STAFF RECOMMENDATION

1420 Calvin Avenue

August 17, 2016

Application: New construction—outbuilding; Setback determination

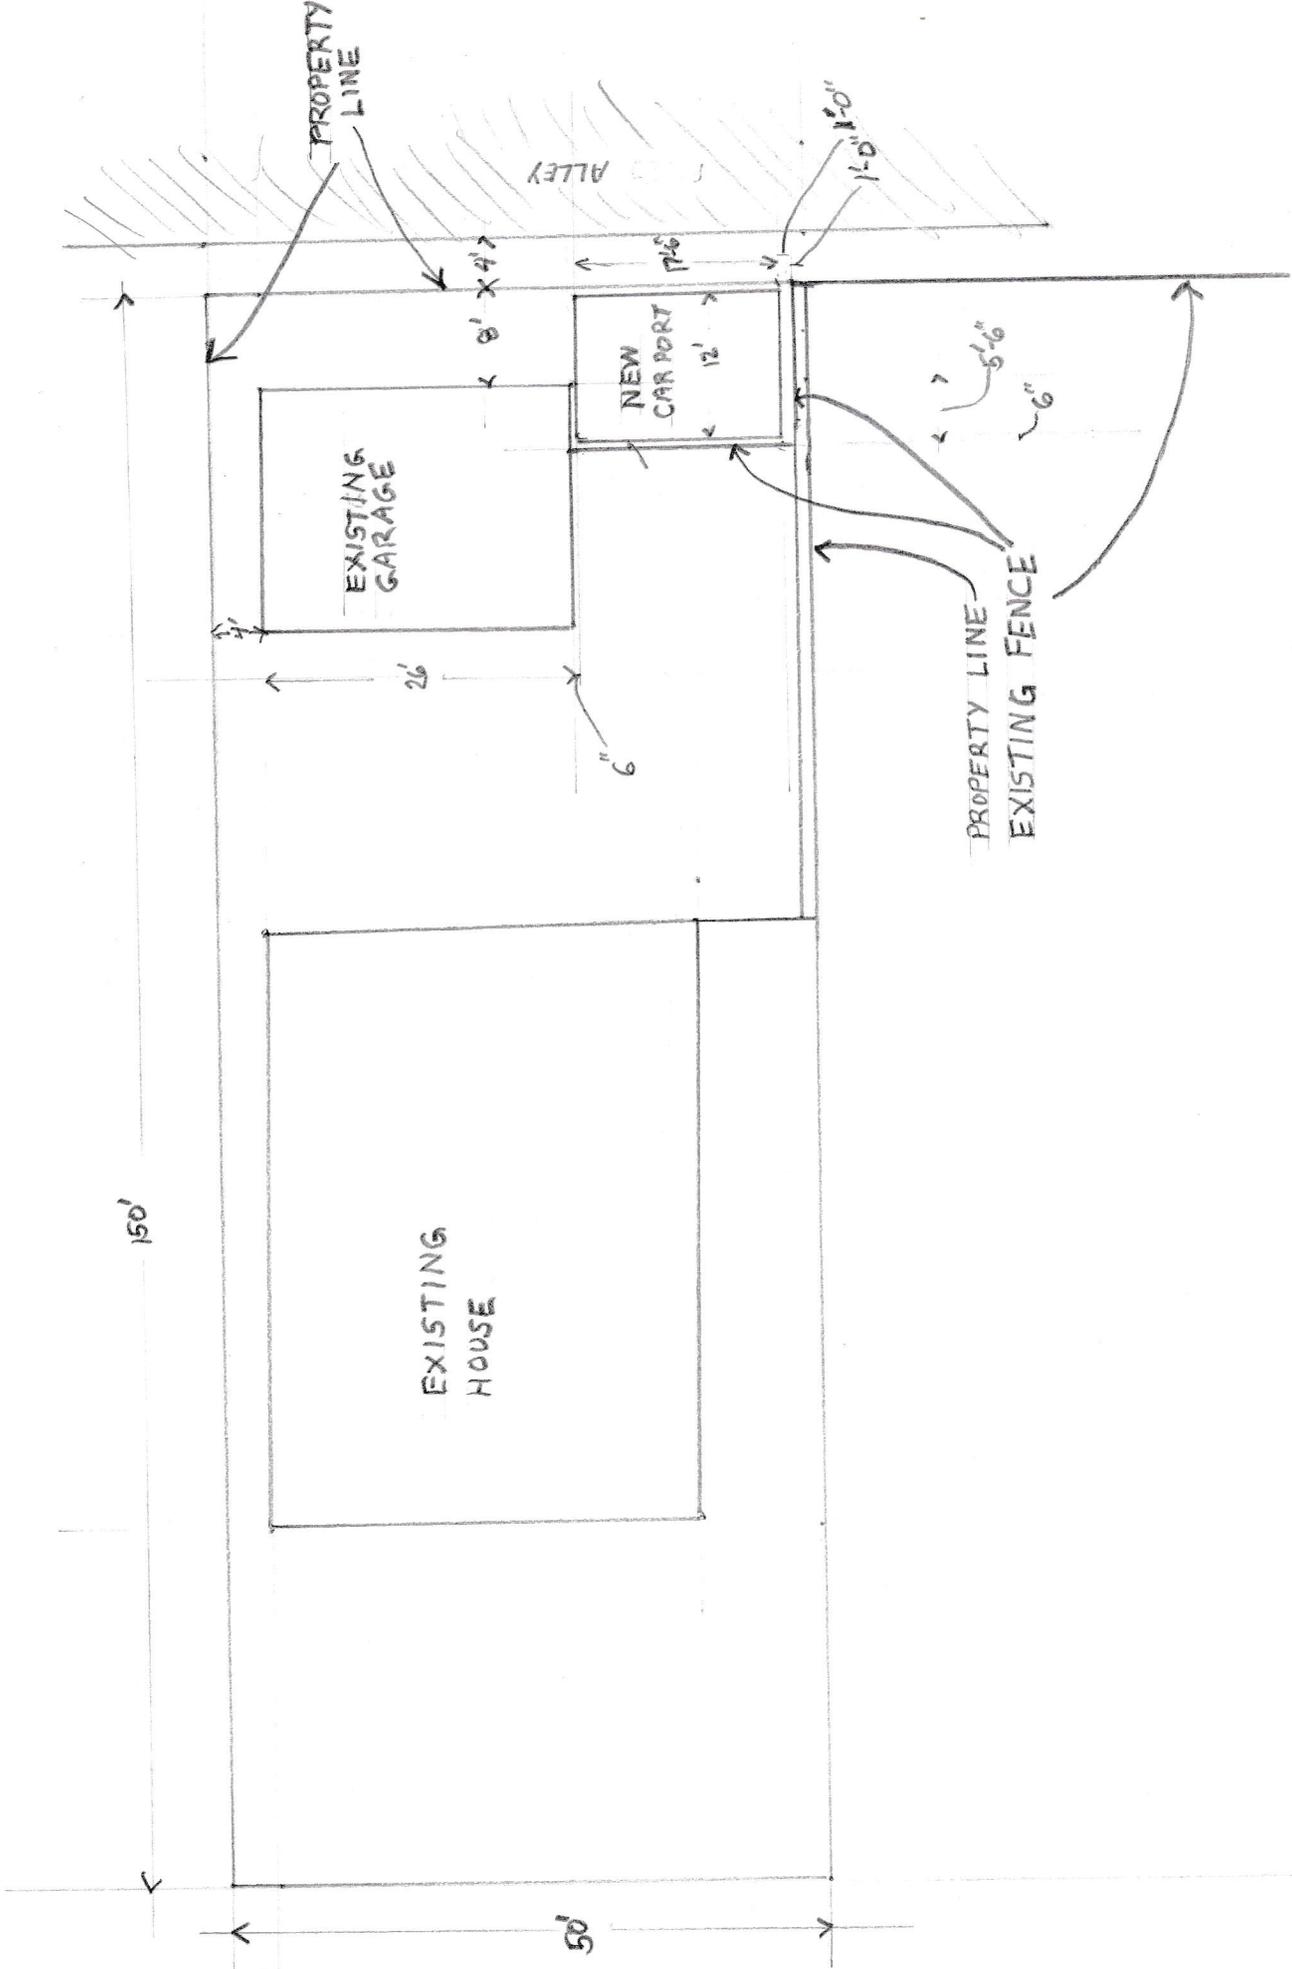
The application is for a carport located in the rear yard that has already been constructed and was not permitted by Codes or by MHZC. The carport is accessed from the alley and is situated very close to the rear and right side property lines. This request requires setback determinations to reduce the right side setback from five feet (5') to two feet (2') and the rear setback from twenty feet (20') to six inches (6").

The existing carport is located two feet (2') from the right side property line and only six inches (6") from the rear property line. Since the total area of outbuildings is greater than seven hundred square feet (700 sq. ft.), the carport must meet the full setbacks of twenty feet (20') for the rear and five (5') feet for the side. Setback determinations take into account historic conditions and while outbuildings were frequently located closer to the side and rear property lines, the setbacks proposed in this case are much closer to the property lines than have been typically approved by the Commission. In addition, the proximity of the carport to the alley may present safety concerns for personal vehicles as well as those used for trash pick-up. Therefore, staff recommends disapproval of the setback determinations, finding that the project does not meet Section II.B.8. of the design guidelines for setbacks.

Recommendation Summary: Staff recommends disapproval of the carport and the setback determinations as the project does not meet Section II.B.8 for outbuildings of the *Lockeland Springs – East End Neighborhood Conservation Zoning Overlay Design Guidelines*.

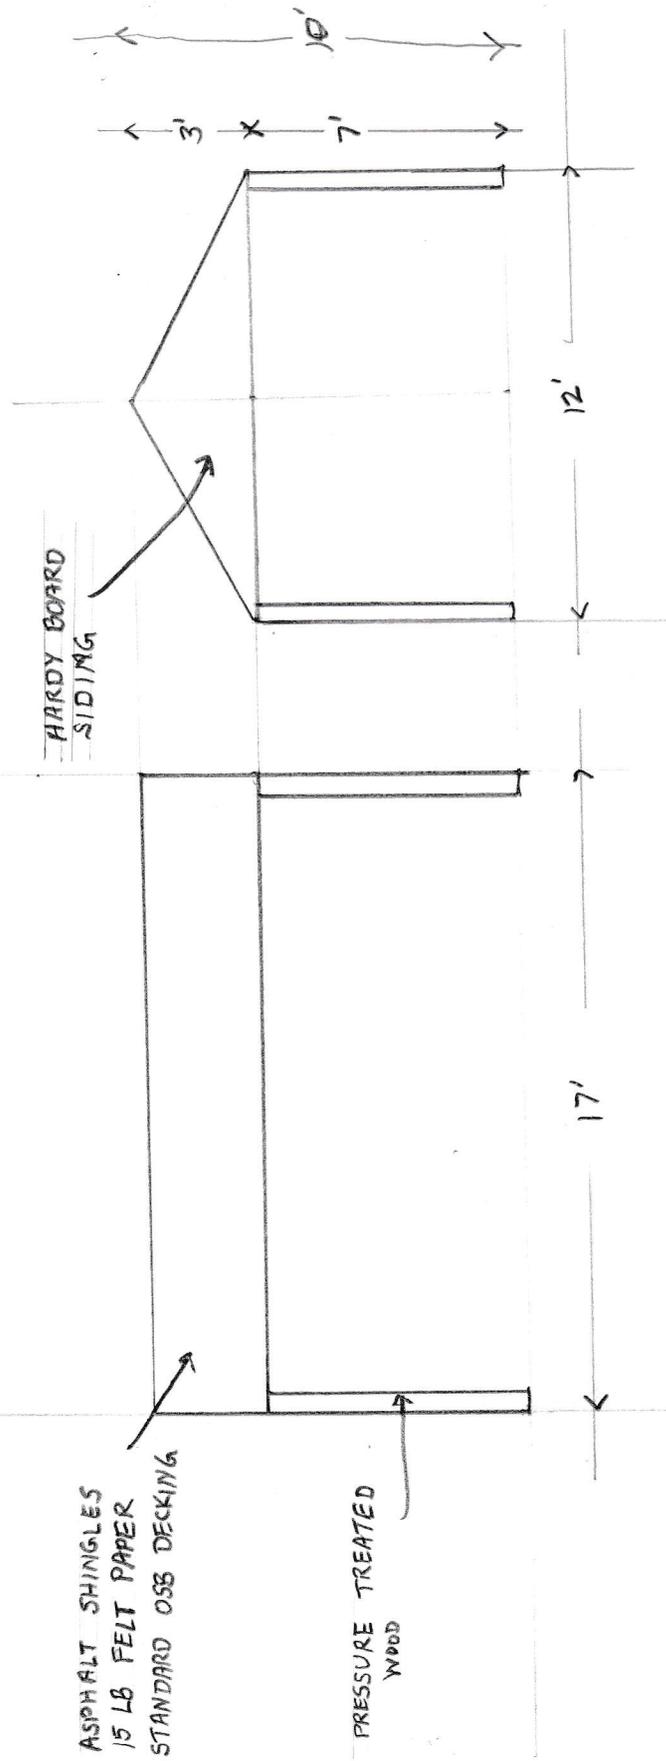
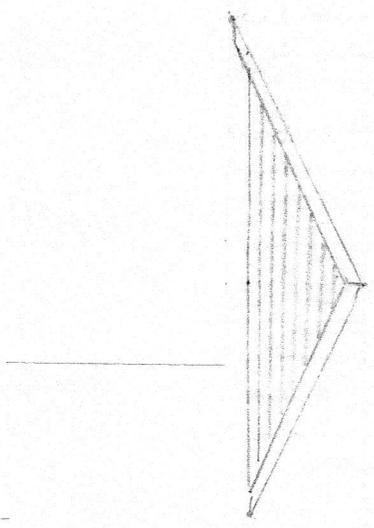
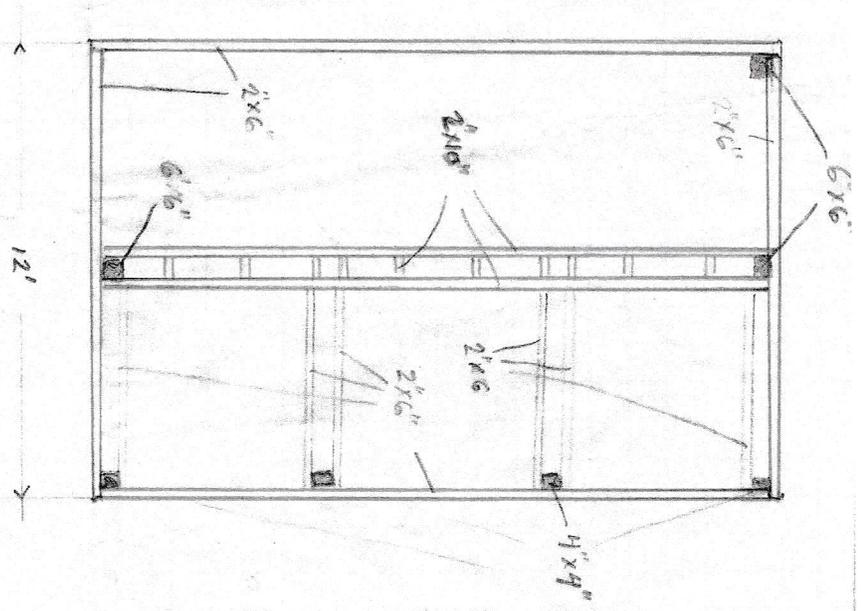
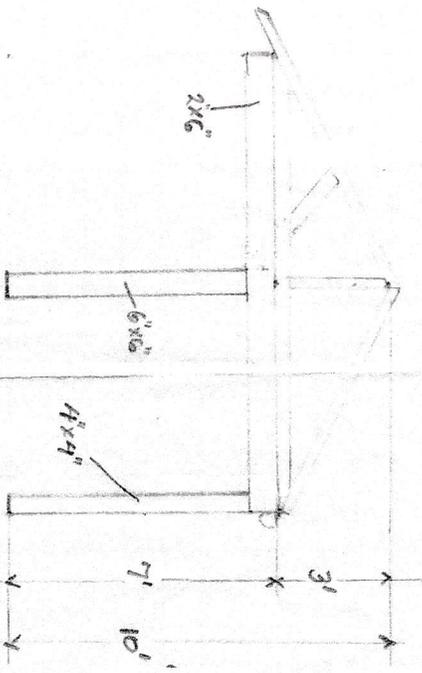
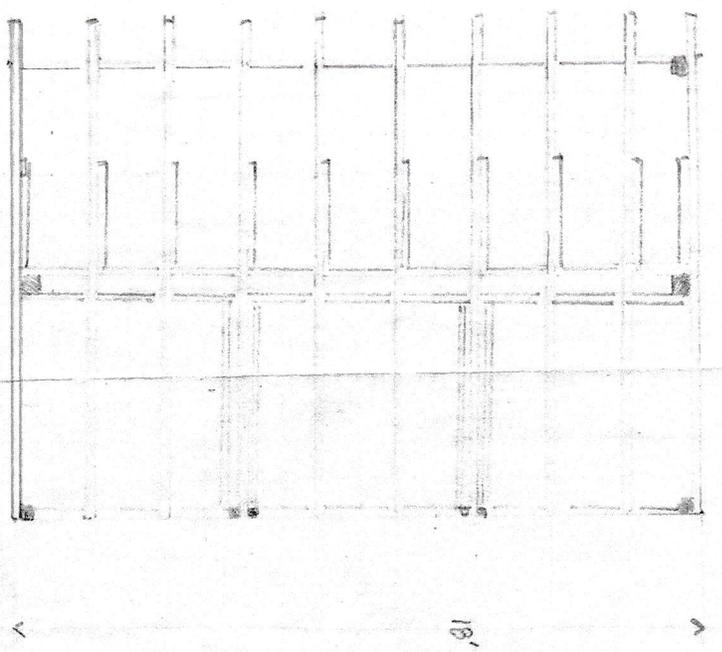
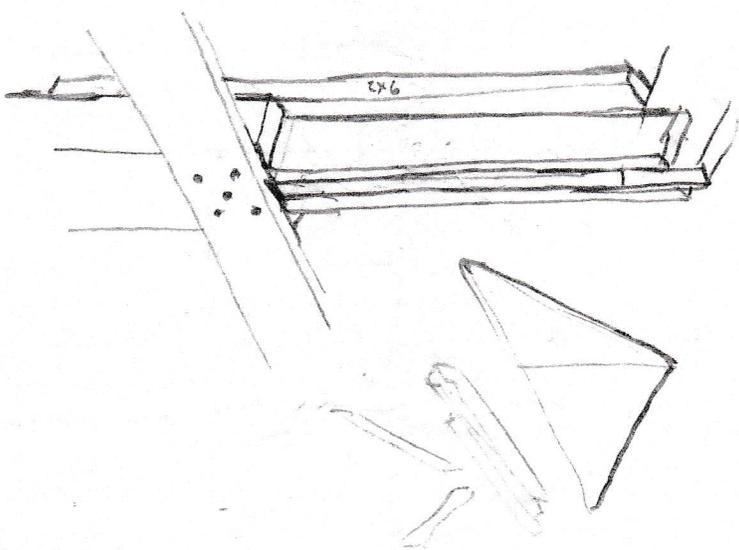
The Hardie board siding used in the gable fields on the sides of the carport is embossed rather than smooth as required. Therefore, the materials do not meet Section II.B.8 of the design guidelines for materials.
